**SITE PLAN REVIEW TECHNICAL ADVISORY COMMITTEE
PORTSMOUTH, NEW HAMPSHIRE**

**RE: Response Letter – Peer Review
635 Sagamore Ave, Portsmouth, NH
Tax Map 222, Lot 19
JBE Project No. 18134.1**

Project: **"LUSTER CLUSTER" 635 SAGAMORE AVE., PORTSMOUTH, NH**

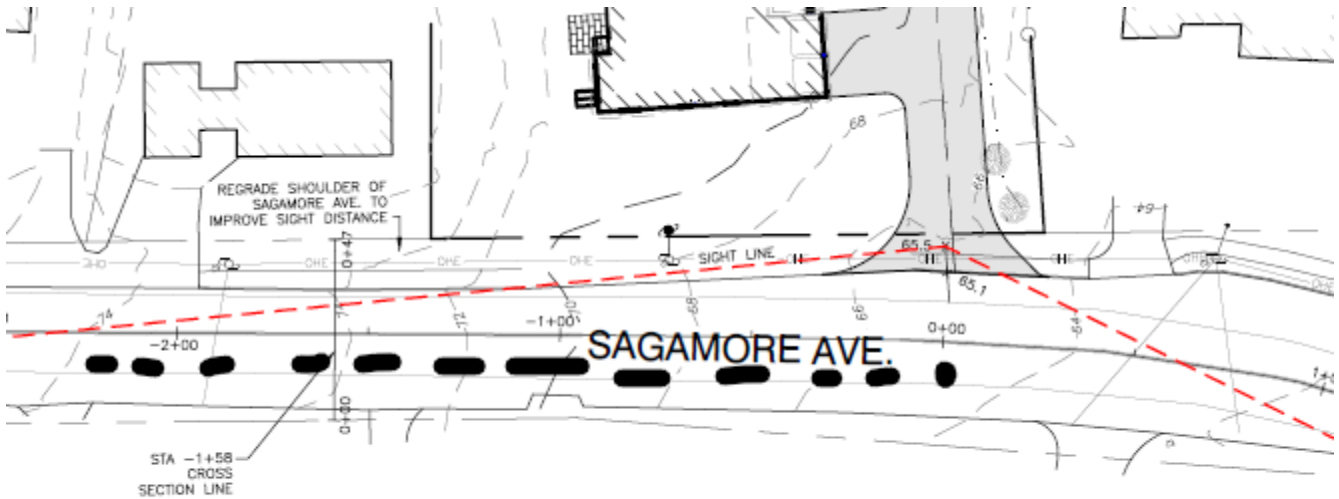
Looking at the plans, it appears that the sight line was plotted along the red dashed line. However, this line would represent the intersection sight line and not the stopping sight line. The 2-foot object height for stopping sight distance needs to be at a point in the travel lane, not at a point 14.5 feet from the edge of the travel lane. Stopping sight distance is for approaching vehicles to be able to see and react to a vehicle stopped in Sagamore Ave waiting to turn left into the site driveway. I don't know how much of a difference, if any, the location of the 2-foot object will have on the sight lines, but it needs to be shown and the report updated to reflect the proper location.

The black dotted line in the figure below illustrates where the 2-foot object should be located.

DRAWING No.
C2
SHEET 4 OF 20
JBE PROJECT NO. 18134.1

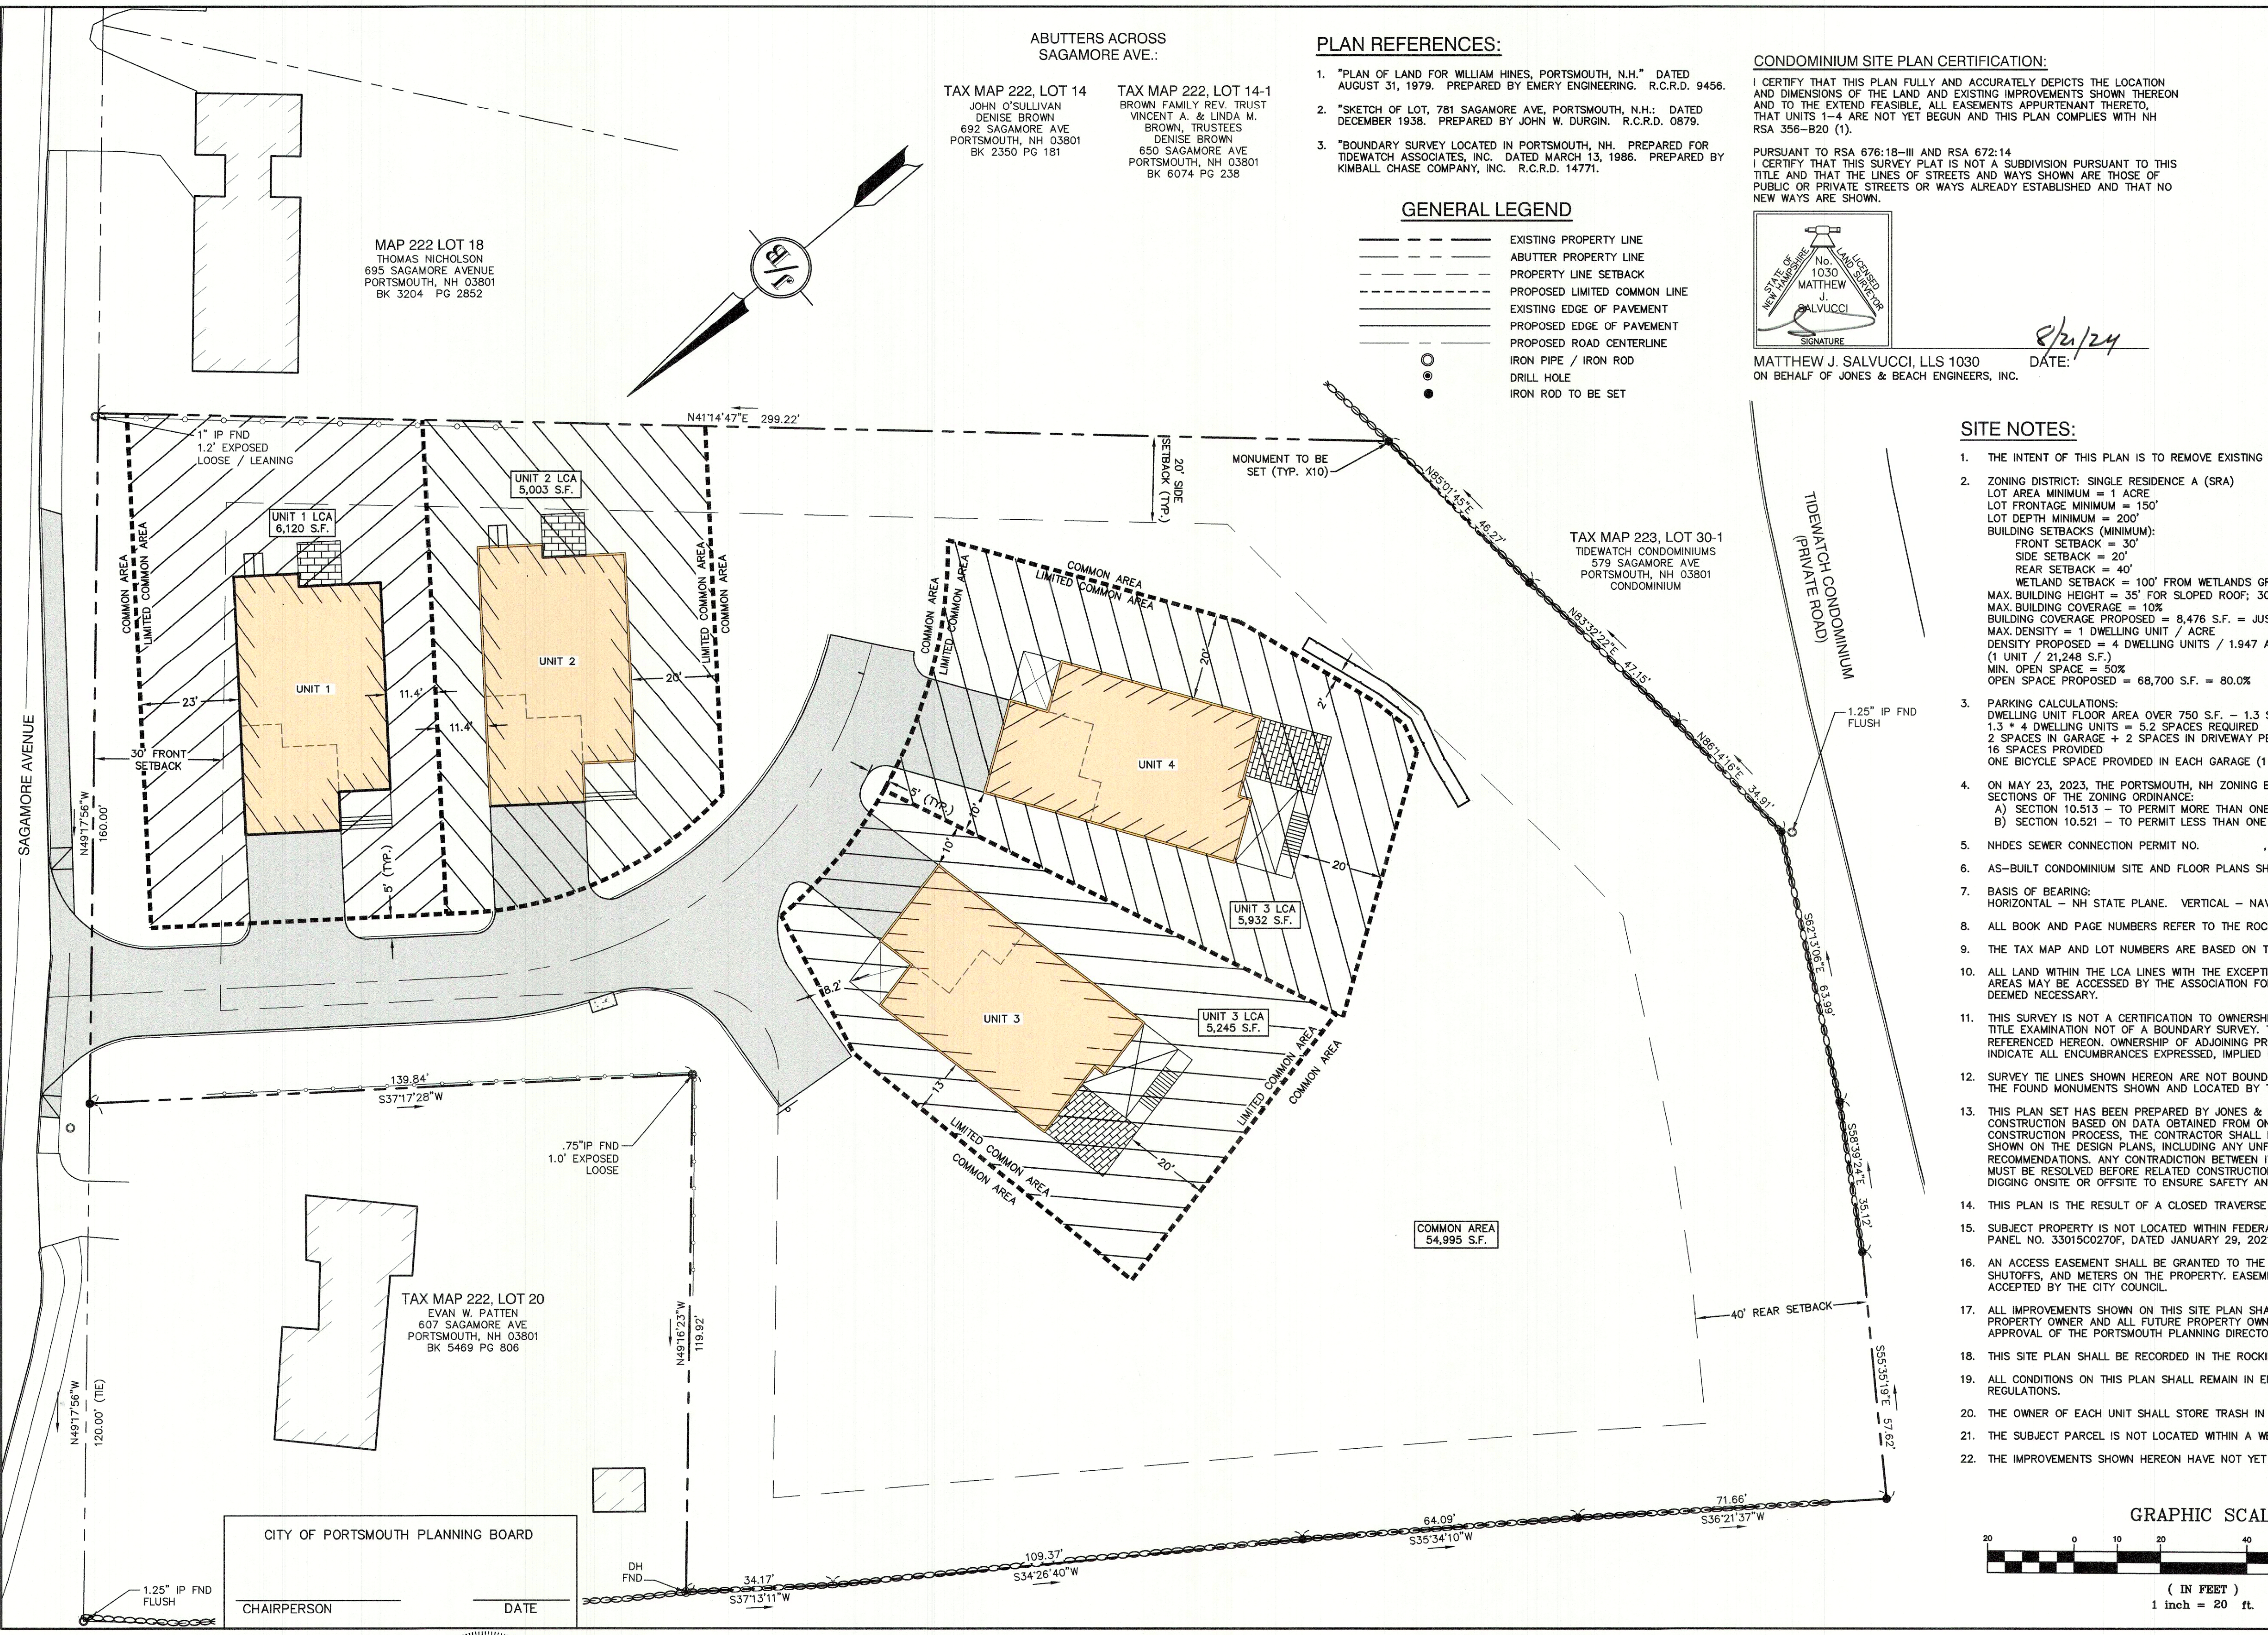
7. Based on the Cuomo report and Altus' observations, note 6 on Sheet C2 needs to be corrected. The 100-foot wetland buffer extends onto the property. The buffer should be depicted on the plans.

RESPONSE: Brenden Walden, CWS, and Mike Cuomo, CWS, determined in the field that the wetlands on the Tidewatch Condominium property are well offsite. See attached letter from RCCD. It is apparent that the proposed disturbance is outside of the wetland buffer, because the proposed disturbance is approximately 100 feet from the far edge of pavement of the Tidewatch Condominium roadway at its closest point. Note #6 on Sheet C2 has been revised.

H1

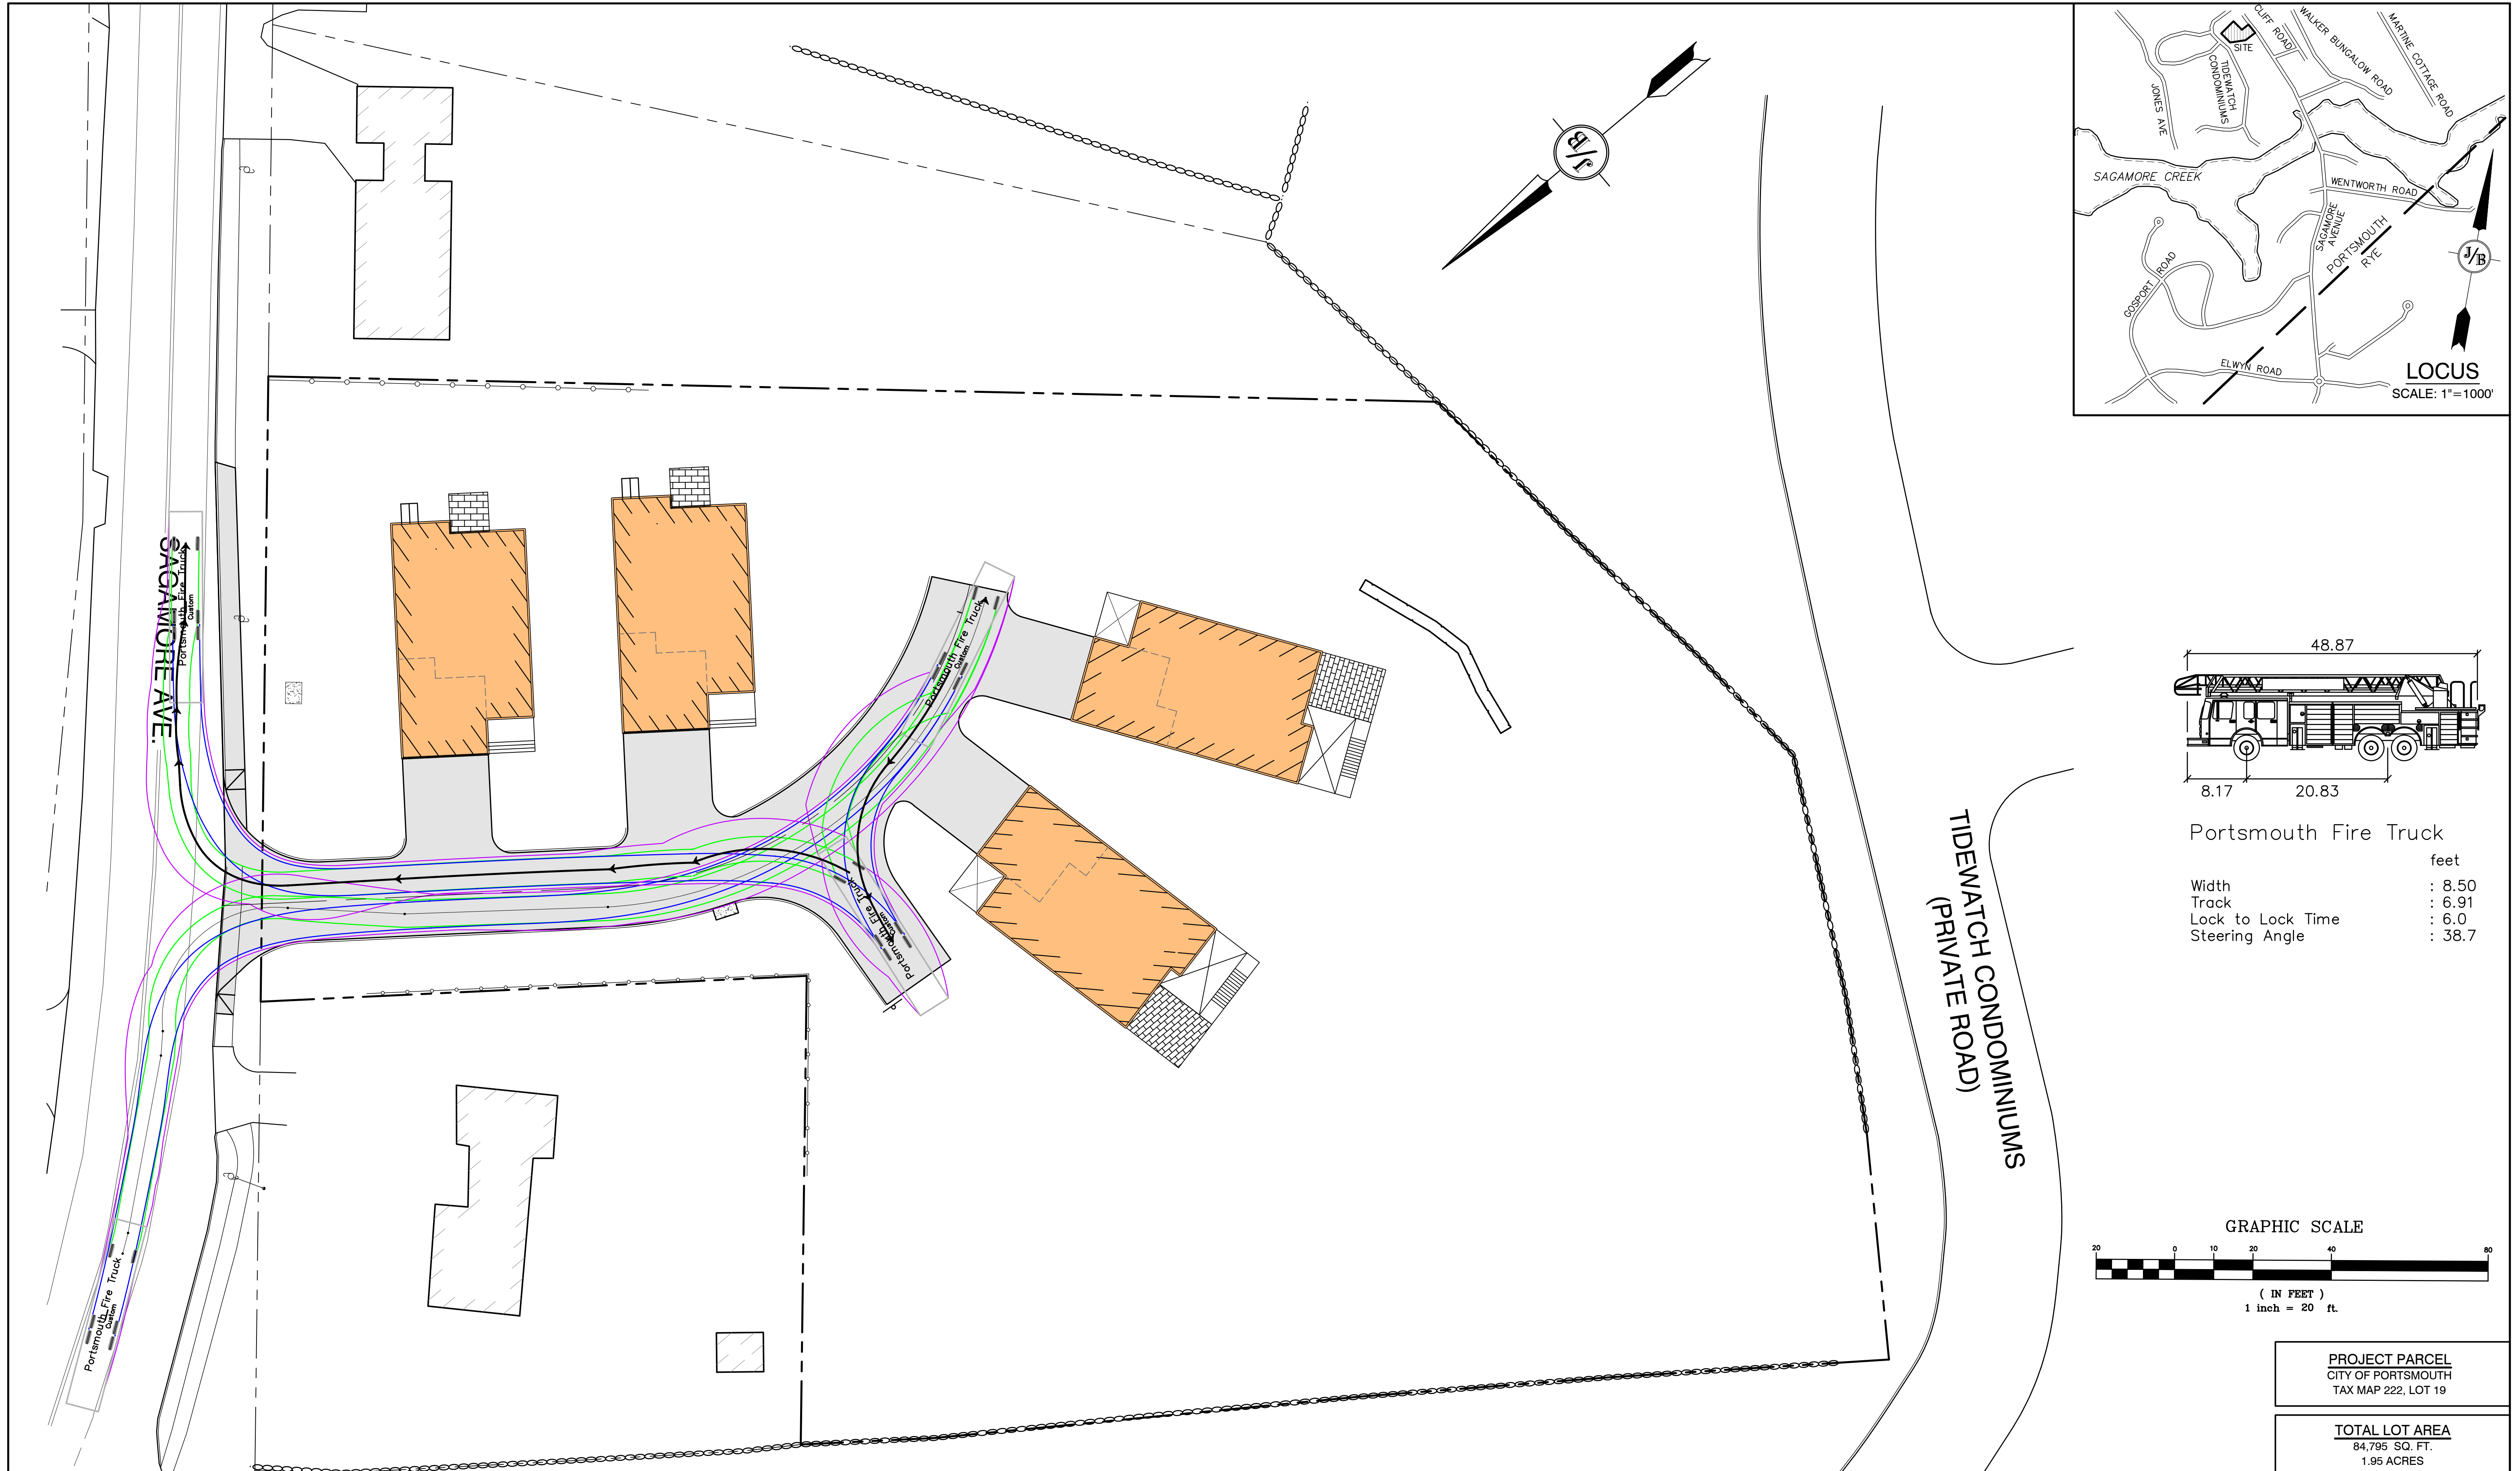
11. The Designer should check the north arrow on the Highway Access Plan.

RESPONSE: The north arrow on Sheet H1 has been revised for accuracy.

ANTI-SEEP COLLAR
NOT TO SCALE

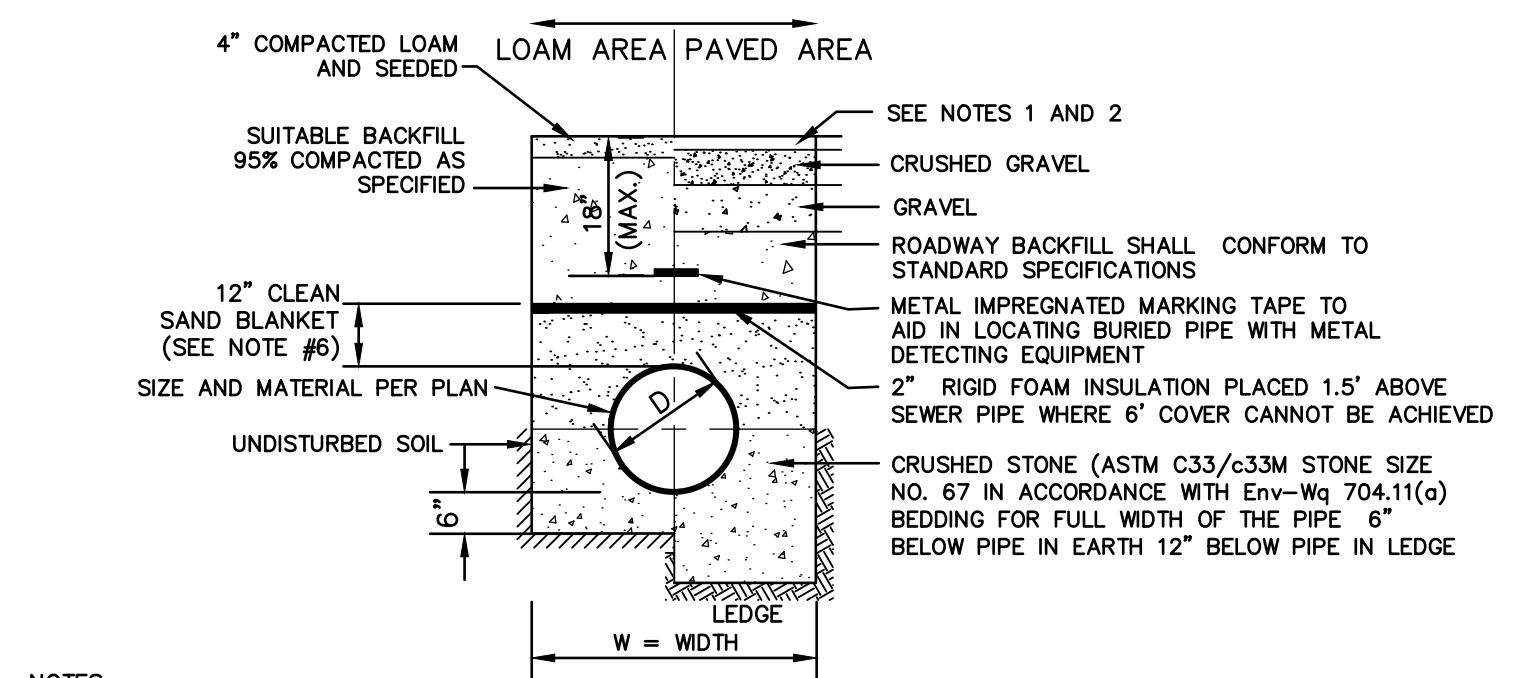
15. *The notes on the anti-seep collar detail conflicts with locations shown on the plans. Clarification is needed.*

RESPONSE: The Anti-Seep Collar detail states that anti-seep collars shall be placed 15' and 25' downstream of a culvert inlet unless otherwise specified, AND that they shall be placed on both sides of a clay core. The outlet culvert from the proposed bioretention pond, which passes through a clay core berm, is only 20' long. Therefore, anti-seep collars are proposed on both sides of the clay core berm. In our judgement there is no reason to place another one 5 feet from the outlet headwall.

CLAY CORE BERM

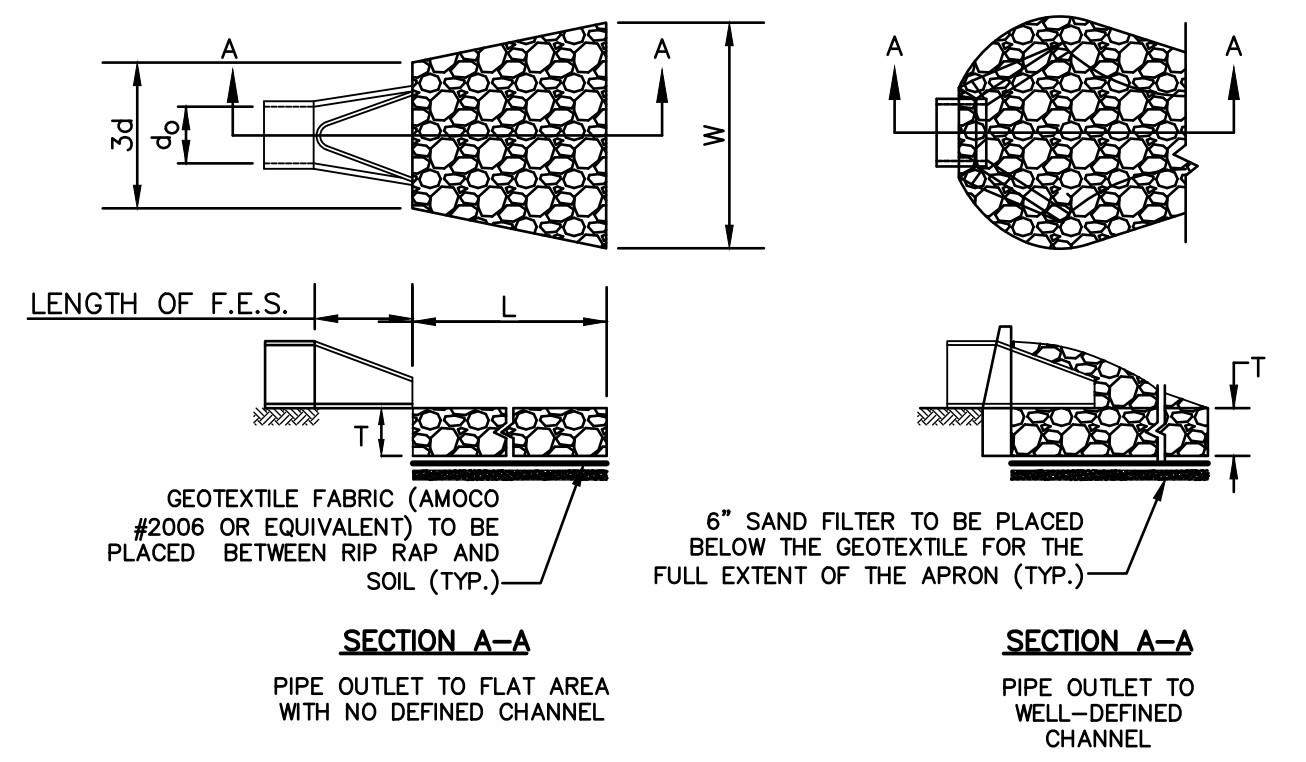
16. It is presumed that the clay core berm will interface with exposed ledge. The detail should clearly note how the interface will be constructed to ensure that there is no seepage.

RESPONSE: Note #5 has been added to the clay core berm detail on Sheet D4, stating that ledge shall be removed to at least 2' outside of and below the clay core.
